BILL OF MATERIALS									
NEXT ASSY Description		NEXT ASSY Number		UNLESS OTHERWISE SPECIFIED TOLERANCES ARE:				APPROVALS DATE	
				1 PLACE DIM $\pm 1/16$	2 PLACE DIM $\pm .02$	3 PLACE DIM $\pm .005$	ANGLES $\pm 1^\circ$	DRAWN 12/9/2014	Monterey Bay Aquarium Research Institute MBARI 7700 Sandholdt RD. Moss Landing, CA 95039 PH: (831) 775-1700
								ENGINEER H. Thomas	
								CHECKED	
								PROJECT NO. 368000	Adapter, 1.0in PNA to .75in PNA
								PROJECT DMO AUV Operations	
								WEIGHT	
								SCALE 2:1	DWG. NO.
								CAD FILE:	
								SHEET 1 OF 1	REV. REV

DETAIL A

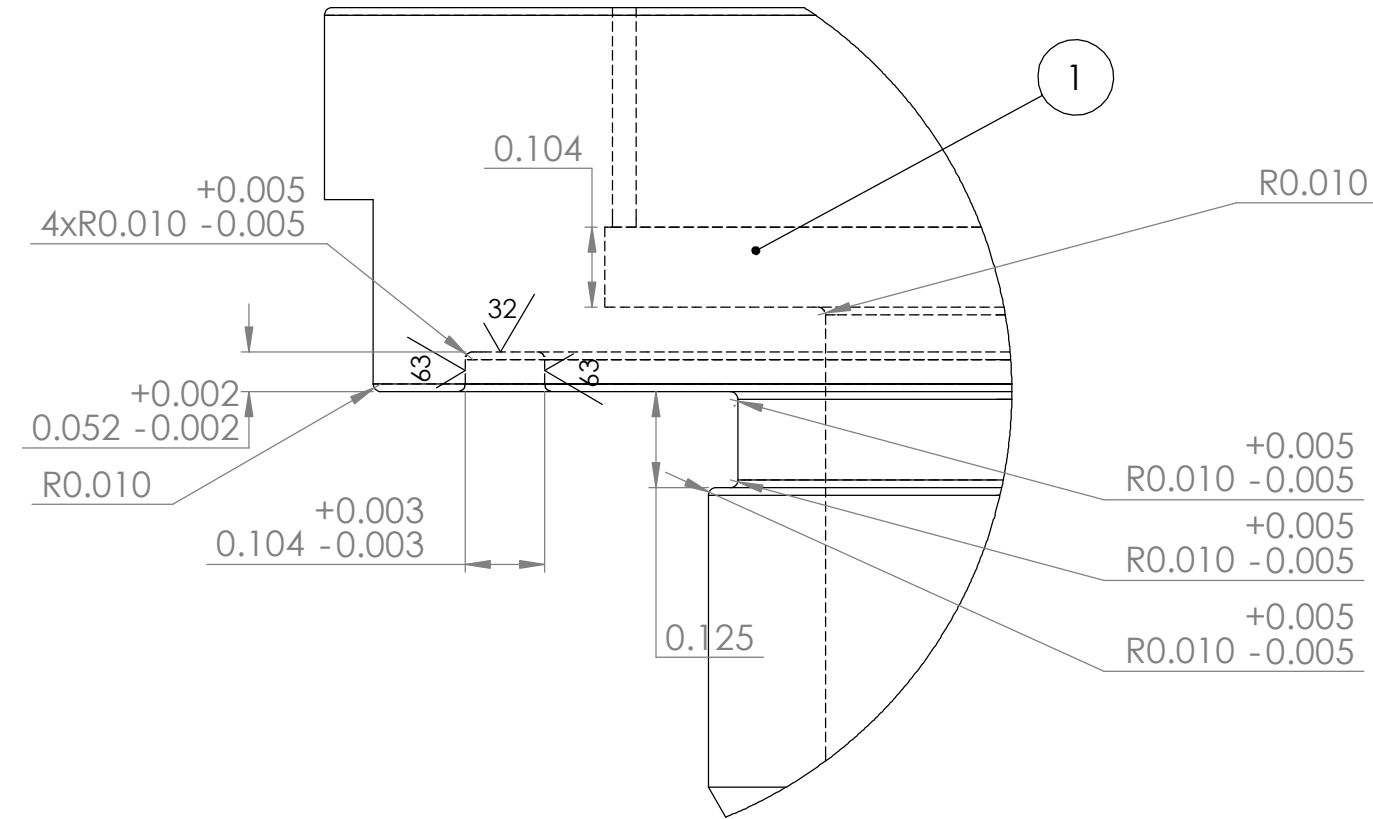
1 Increase depth of thread relief bore from .380 to .390. Keep R.010 Fillet.
